**PERSIMMON HOMES
NORTH LITTLEHAMPTON PHASE 1
TODDINGTON LANE S278 WORKS**

AMENDED IDR ARRANGEMENTS

**ROAD SAFETY AUDIT RESPONSE
REPORT TO STAGE 1 RSA ADDENDUM**

Project Code:	PHLITTLE.2/IDR-DR
Prepared by:	AB
Approved by:	SW
Issue Date:	3 MAY 2016
Status:	1st ISSUE

PROPOSED S278 HIGHWAY WORKS
AMENDED IDR GENERAL ARRANGEMENT DRAWING

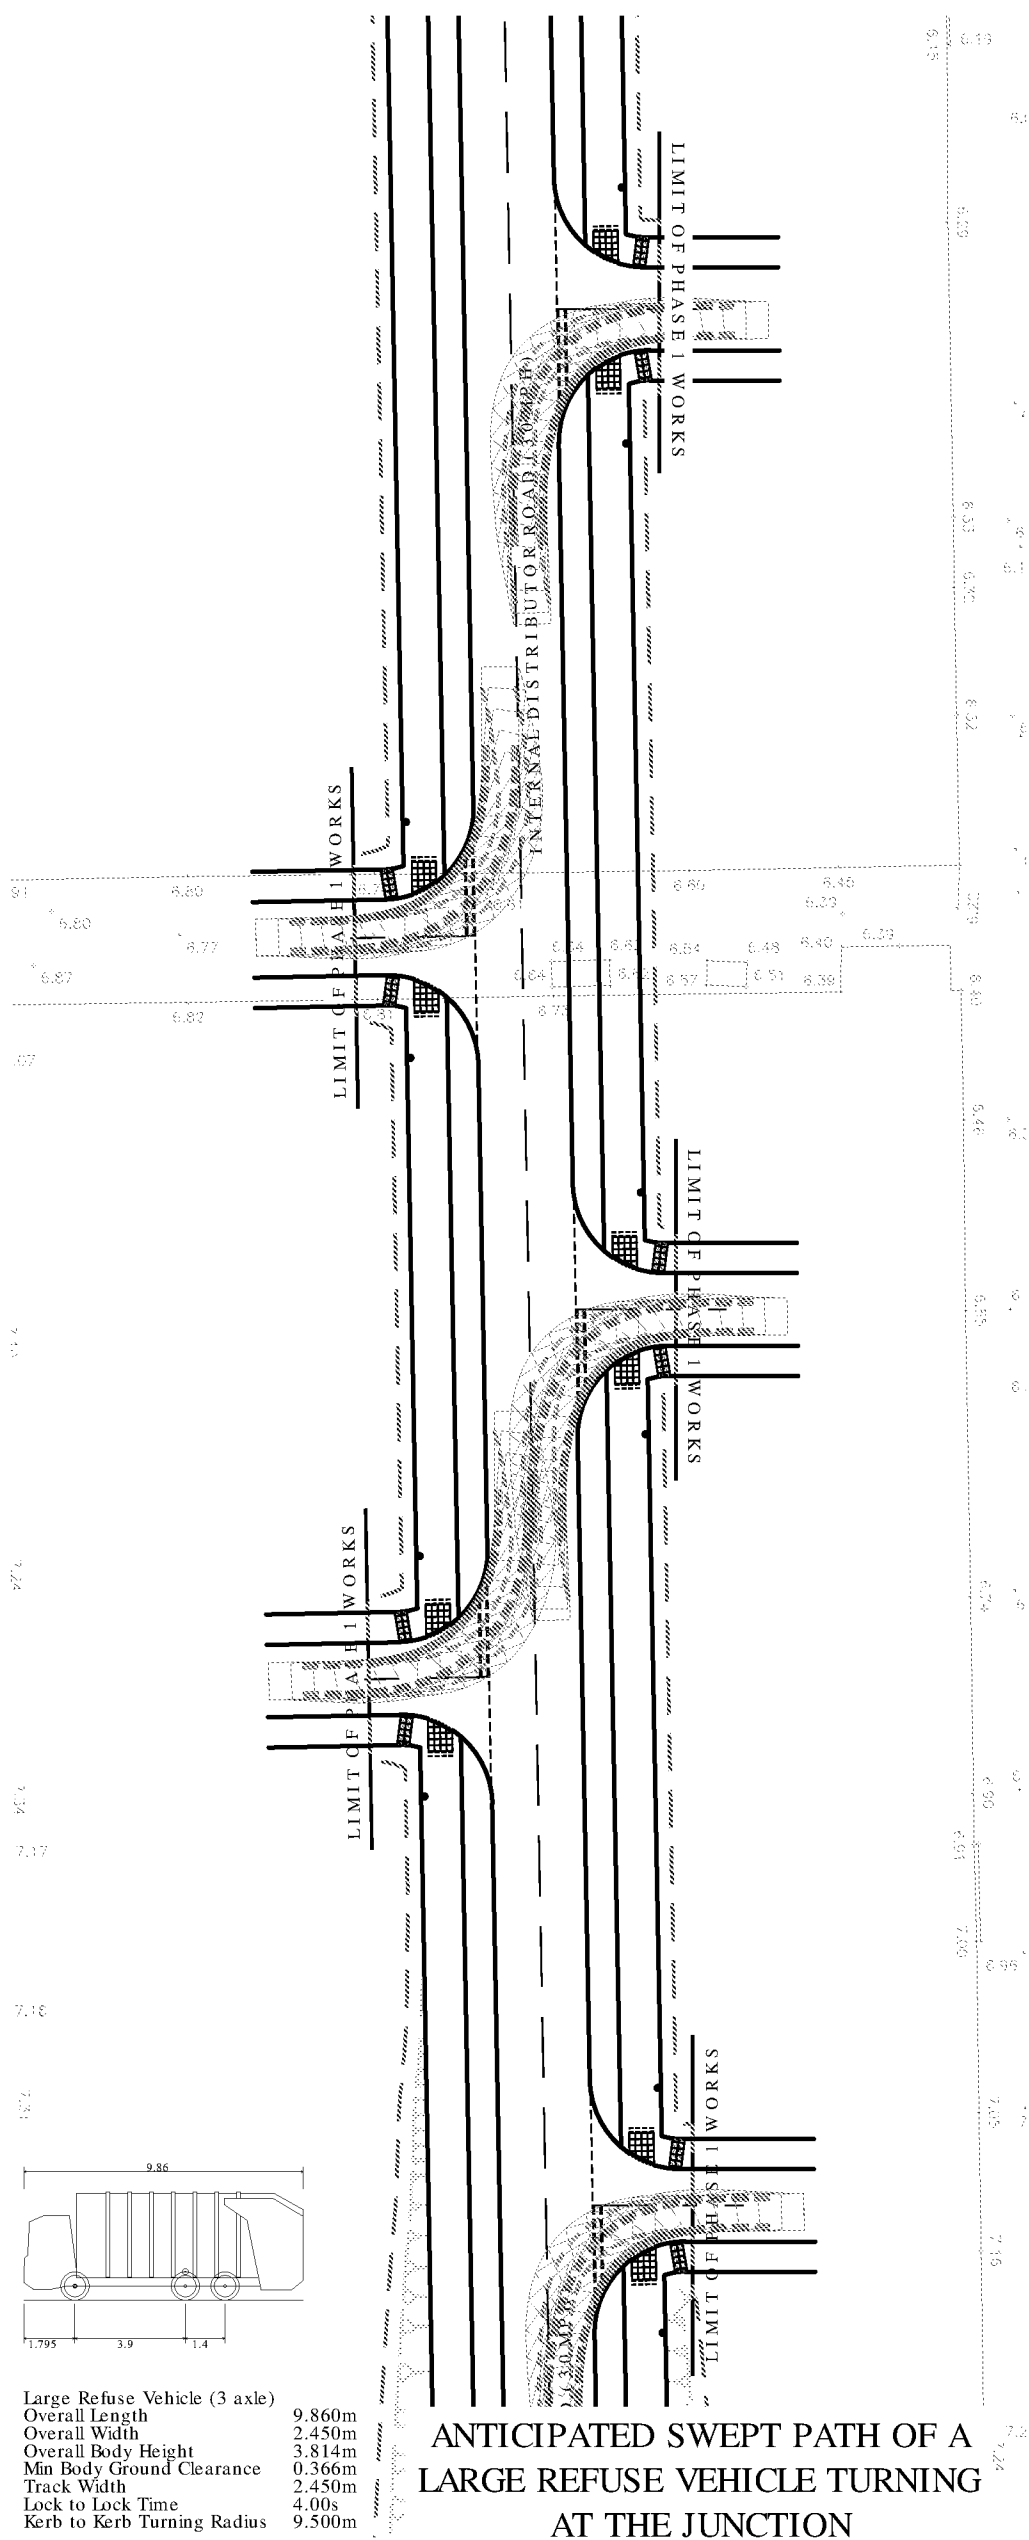
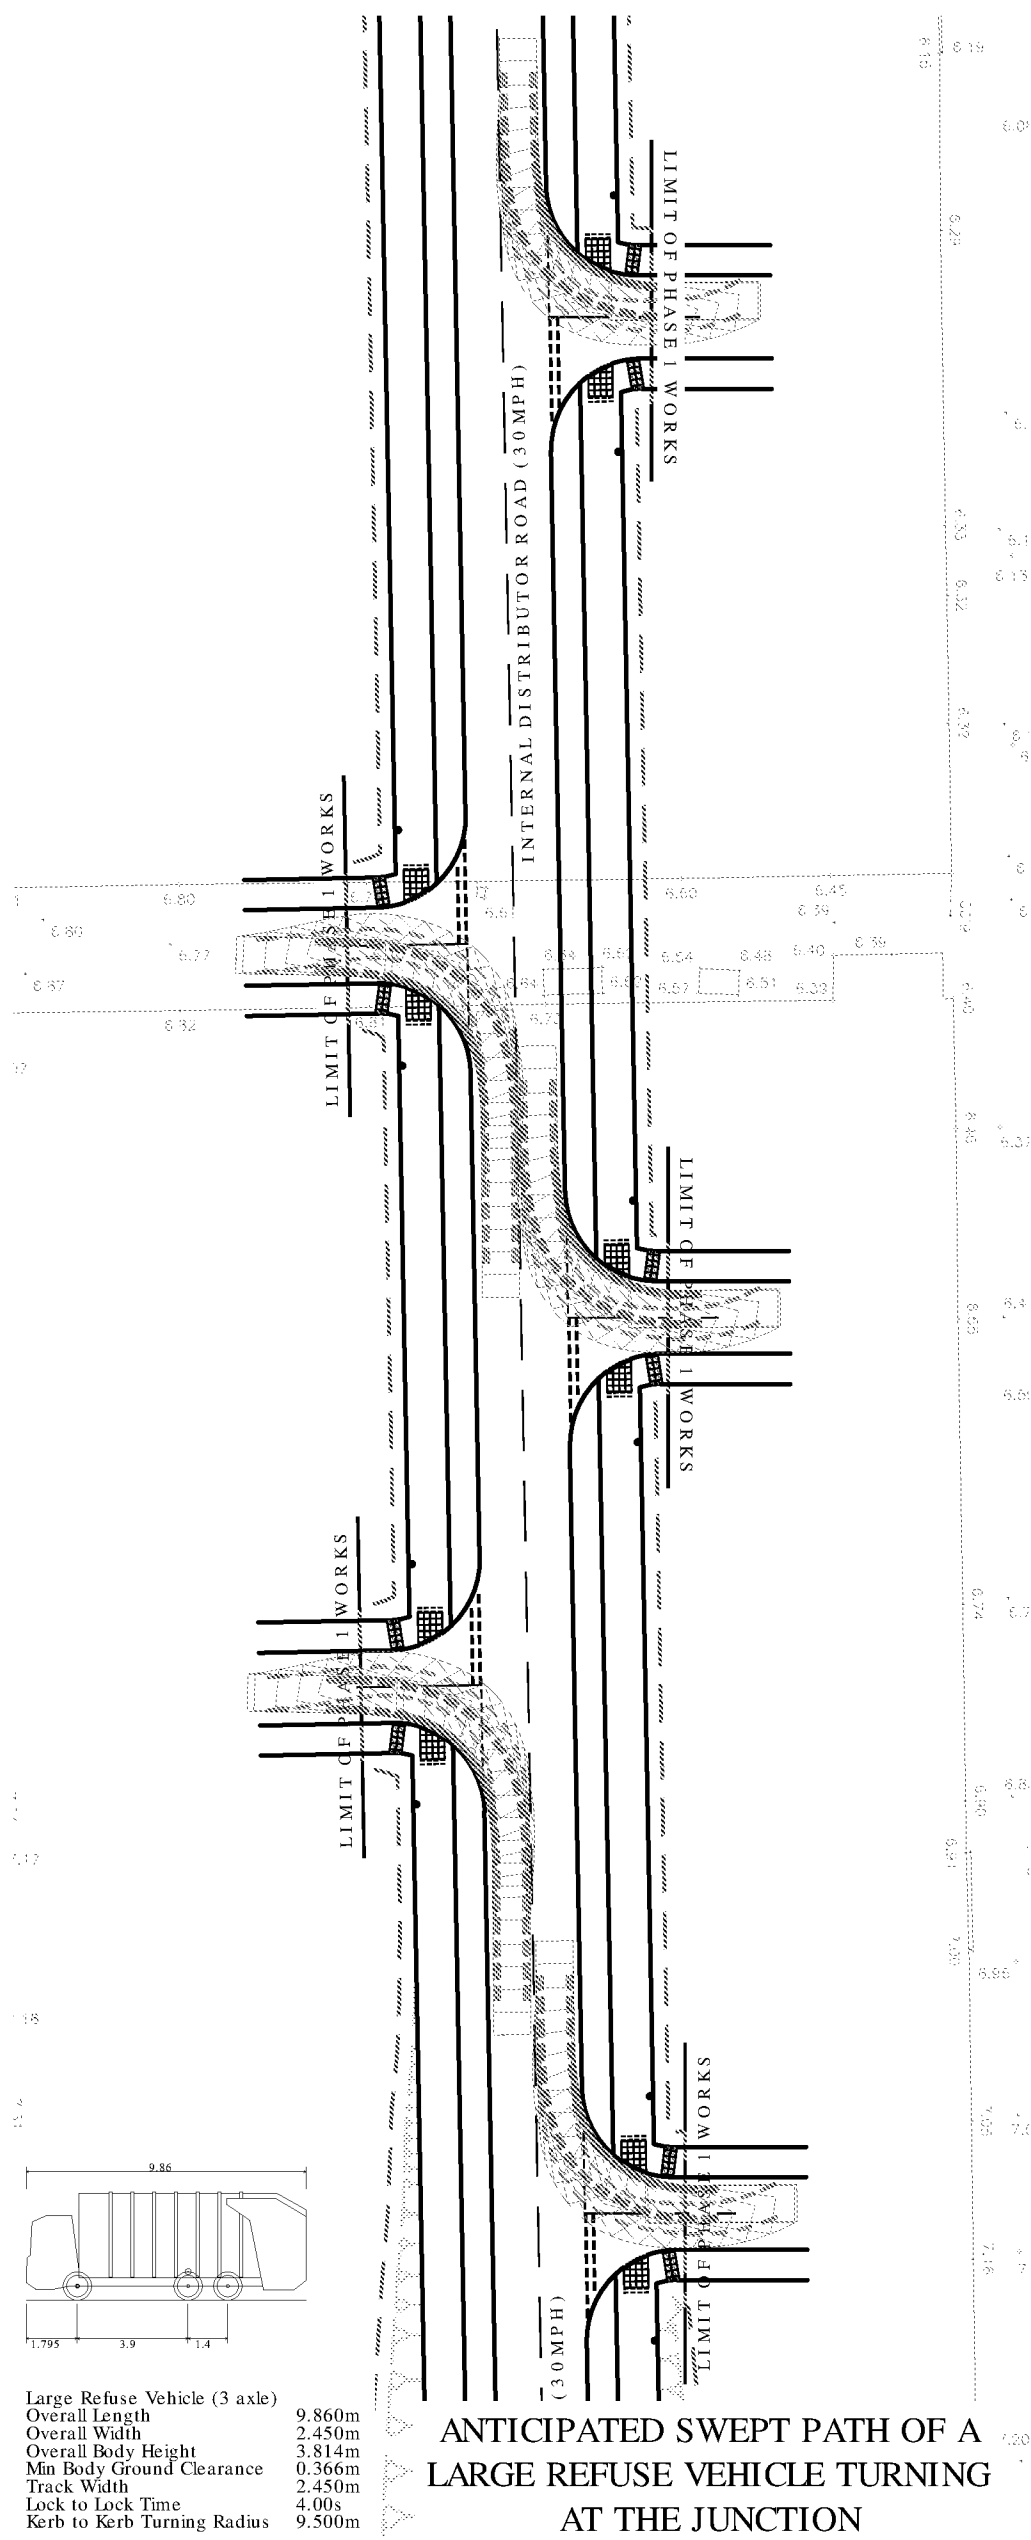
The drawing shows a 20m kerb radius on the west side of the junction. This could encourage relatively high speeds by left-turning vehicles, particularly cars and light vans, and it increases the width of carriageway to be traversed by pedestrians crossing the junction; both of these factors increase the danger to pedestrians from turning vehicles. Whilst it appears from the traffic flow information supplied in the Audit Brief that a significant number of HGVs will use this junction, it is clear from the swept path plots that the radius could be reduced without causing them difficulty.

- i. Reduce the kerb radius as far as possible consistent with providing adequate turning space for the largest vehicles regularly using the junction.
- ii. Inset the pedestrian crossing point slightly further into the junction (c.1.5m) to reduce the crossing width for pedestrians, particularly those with a disability, and increase their visibility to/from southbound vehicles approaching on the IDR.

A considerable number of trees is shown within the verges on both sides of the IDR, some of which are within designated junction visibility splays. Whilst we note that the trees are intended to be of relatively small girth and have clear stems, they will inevitably have some impact on sightlines; this effect will be greater the closer they are to the junction and will increase with time as the trees grow. This will increase the risks of vehicles emerging from the side roads being struck by passing traffic, and of cyclists approaching a junction along the shared path being concealed from drivers intending to turn into the side road.

Do not plant trees within the visibility splays.

Whilst the shared path provision should increase cyclists' safety by removing them from the carriageway, this benefit is likely to be largely nullified by the frequent interruption of the route by side road junctions where cyclists are not given priority; in these circumstances, although children may cycle along the path, confident cyclists are more likely to remain in the carriageway to avoid the possible need to keep stopping. In addition, the side road junctions are drawn with 8m kerb radii, which will not significantly reduce turning vehicle speeds to maximise the safety of pedestrians and cyclists. In accordance with Manual for Streets advice it would be better in most cases to keep kerb radii to a minimum and accept that larger vehicles will occasionally need to cross into the opposing lane of the IDR to make the turn. The Auditors have not been provided with details of the individual development areas to be served off each side road, but in some cases (i.e. if only a small number of dwellings is proposed) it may be appropriate to provide access in the form of a dropped kerb and footway crossing rather than a kerbed bellmouth. Alternatively it may be appropriate to provide entry treatments such as entry ramps, raised tables and/or set back Give Way markings.

Reconfigure the side road junction treatment (providing cycle priority if possible) to improve continuity of the cycle route.

- (i) Accepted. Kerb radius reduced, as recommended, by the provision of a compound kerb.
- (ii) Accepted. Crossing point inset 1.5m further as recommended.

Accepted. 16 no. trees within visibility splays removed as recommended.

Accepted. Junction radii were initially indicated to be 6m but WSCC requested via comments dated 11 Feb 2015 that we consider increasing them. Subsequently, the radii were increased to 8m. However, the radii have been reduced back to a minimum of 6m as recommended. As set out in the Auditor's summary, this will require larger vehicles such as the occasional refuse vehicle to cross into the opposing lane to make the turn, although this would have happened with the 8m radius as well.

D	Trees amended & Toddington Lane junction and Development access junctions amended following Stage 1 Road Safety Audit Addendum Report. (OIN)	AB	03/05/2016
C	Cycle intervisibility spays shown. (OIN)	AB	29/04/2016
B	Indicative Residential layout and pedestrian intervisibility spays added. (OIN)	AB	27/04/2016
A	Trees and tree types added. (OIN)	AB	30/03/2016
